Subject: Clarification and Minor Amendment to the Menlo Park Mercado District  
Planned Area Development (PAD): Allow Compact Parking Spaces

**RE: Minor PAD Amendment – PAD 10**

**SUBJECT: The Mercado District of Menlo Park (PAD-10) "Town Center"  
Area Minor Amendments**

Subject: Clarification and Minor Amendment to the Menlo Park Mercado District Planned Area Development: Private Alley Perimeter Yard Minimum Setbacks for 212 S. Avenida del Palo Fiero

# ASSESSOR'S RECORD MAP

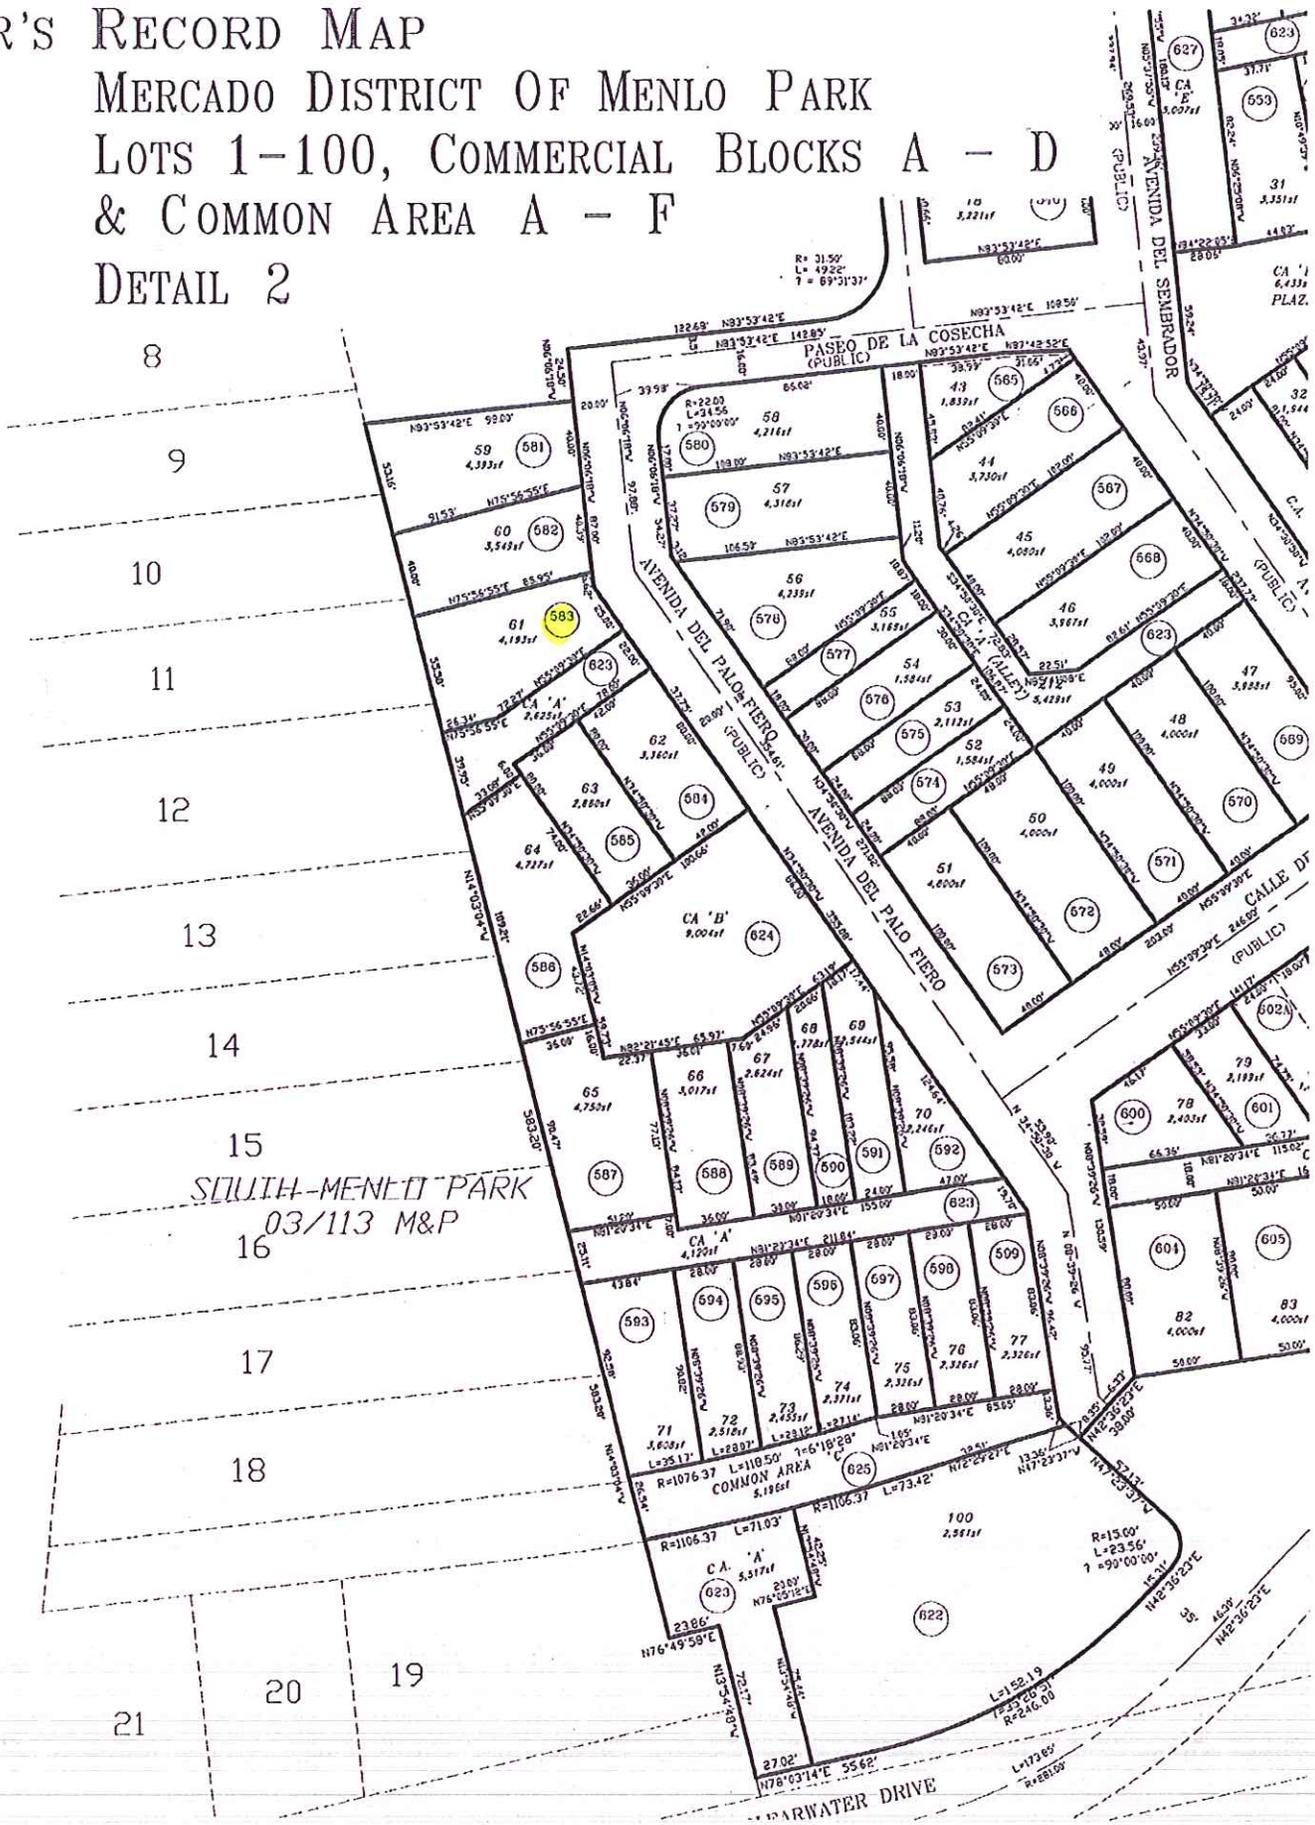
Sorry to keep bugging you about this, but I have some new information to share with you. See the attached Assessor's Map. In my request for your re-consideration of the setbacks last week, I suggested to you that the alley in question (immediately south of the property) is 18 feet wide. I had been looking at the tentative plat for the Mercado, and an 18' dimension does appear on the tentative plat, although the arrows for that 18' dimension do not point from property line to property line. The alley scales at 22' wide on the tentative plat. It has been brought to my attention that the alley is actually 22' wide, not 18' wide like I had described. It shows up as 22' wide on the final plat, and also on the Pima County Assessor's map. So it is the widest alley in the Mercado District.

Now, however, I am noting that the actual alley width in question is 22', not 18' as elsewhere in the Mercado District. Will you consider now that, with the extra 4' of width, that a 1' setback along the alley is not needed?

The PAD recognizes and allows for minor adjustments to development standards that are in the interest of the community and do not affect health or safety issues. The proposed zero setback at the private alley for both dwelling wall and garage for 212 S. Avenida del Palo Fiero (Lot 61) is considered a minor change as referenced in the Menlo Park Mercado District PAD because:

- The proposed design meets the intent and vision of the Menlo Park Mercado District PAD for new urbanism design that creates a clear unique architectural identity through the use and incorporation of private alleys;
- The subject Private Alley has a minimum width of 22-feet that widens to 24-feet;
- The proposed Zero setback meets the intent of the Private Alley Exhibit requiring 24-feet of maneuverability space at garages;
- Lots 62 and 63 with a 3-foot garage setback will have a minimum width of 25-feet for garage maneuverability;
- Distance between garages for Lots 61 and 64 meets 24-foot width of maneuverability required at garages.

Therefore, it is determined that this request is consistent with the intent of the Menlo Park Mercado District PAD, and is a non-substantial change and is approved. Please note that a copy of this letter must be attached to any development plan submitted for 212S. Avenida del Palo Fiero.
